UNITED STATES PATENT AND TRADEMARK OFFICE

APPLICATION NO.	FILING DATE	FIRST NAMED INVENTOR	ATTORNEY DOCKET NO.	CONFIRMATION NO.
10/643,638	08/18/2003	Peng Zhou	COOL-01500	4432
28960	7590	09/05/2006	EXAMINER	
HAVERSTOCK & OWENS LLP 162 NORTH WOLFE ROAD SUNNYVALE, CA 94086			EARLY, MICHAEL JACOBY	
			ART UNIT	PAPER NUMBER
			3744	
DATE MAILED: 09/05/2006

Office Action Summary	Application No. 10/643,638	Applicant(s) ZHOU ET AL.	
	Examiner Michael J. Early	Art Unit 3744

DETAILED ACTION

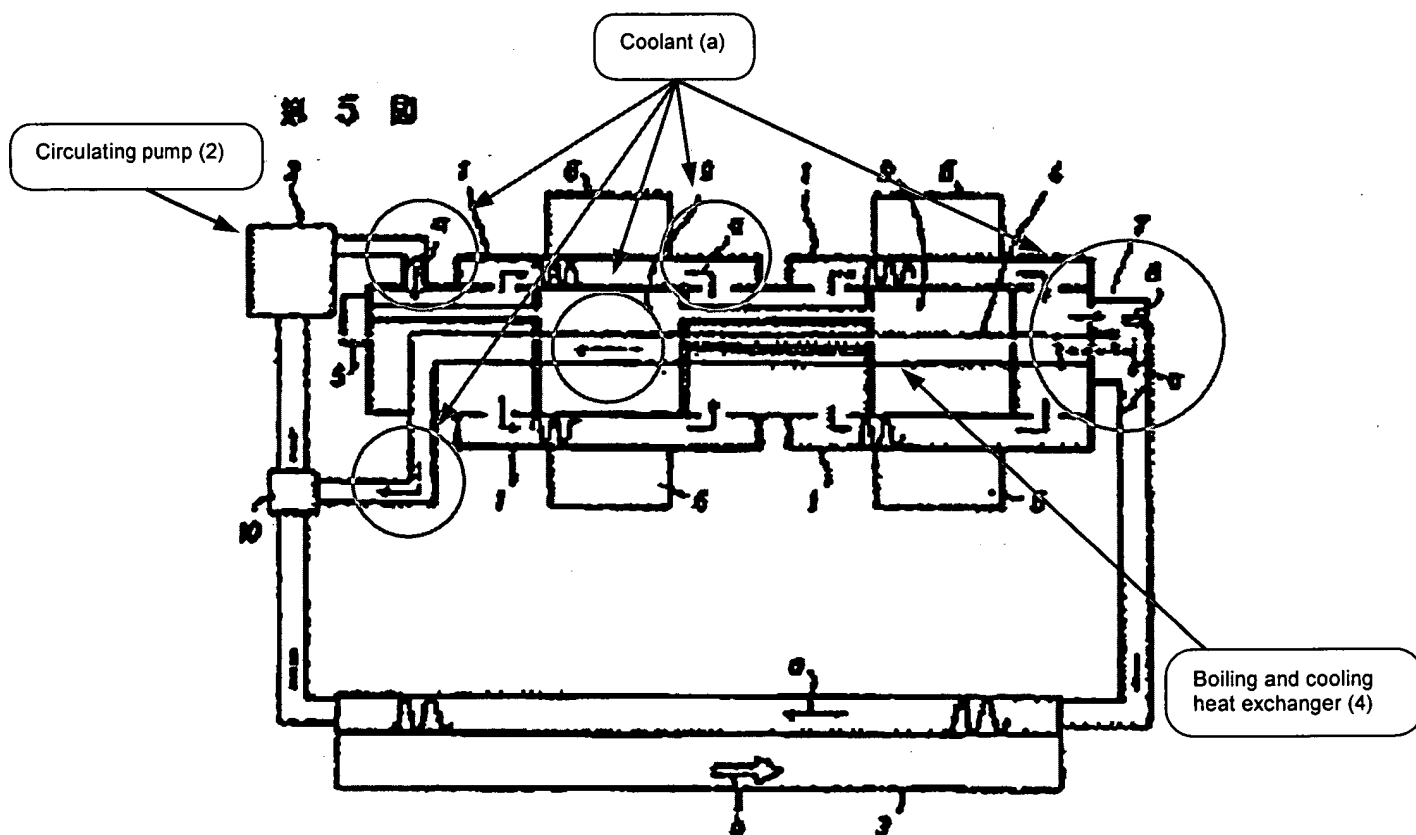
Koo et al. discloses applicant's basic inventive concept, a method of cooling a heat-generating device (IC Chip, Figure 1), using a pump (Electrokinetic pump, Figure 1) to cause a fluid flow in a heat exchanger (Microchannel Heat Exchanger, Figure 1) and having a heat rejector (Condenser, Figure 1) for rejecting heat from the system, located downstream from the heat exchanger. Koo et al. further disclose that both the pressure drop and pump power are dependent upon the mass flowrate of the flowing fluid within the system (see page 425, last paragraph).

Yamaguchi teaches that adjusting the pressure of the refrigerating fluid in the heat exchanger will correspondingly adjust the boiling point temperature of the refrigerant for evaporation cooling, via a relief valve (5), to be old in the refrigeration art (see constitution; English translation of Yamaguchi, page 4, paragraph 3; Figure 5). Yamaguchi further disclose that the circulated coolant (a) is pumped, via circulating pump (2), through the boiling and cooling heat exchanger (4), therefore making the system an "active" cooling system (see English translation of Yamaguchi; page 2, line 1 – page 3, line 3; illustration of Figure 5 below).

Regarding claim 1, it would have been obvious to one having ordinary skill in the art at the time the invention was made to modify the system of Koo et al. by adjusting the pressure of the refrigerating fluid to correspondingly adjust the boiling point temperature of the refrigerant, as taught by Yamaguchi, in order to provide efficient cooling of the system and permit higher fluid temperatures, which in turn would maximize the heat exchanging capability of the apparatus (see Constitution).
